# ServiceInfo 2/2025

## New product Klübersynth LM 8-22

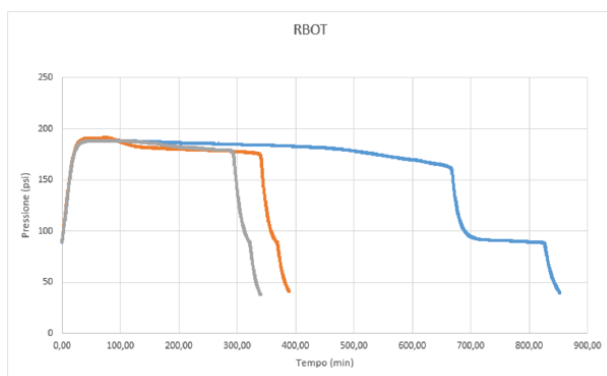
- The viscosity index improves from **291** to **349**, ensuring better fluidity at low temperatures.
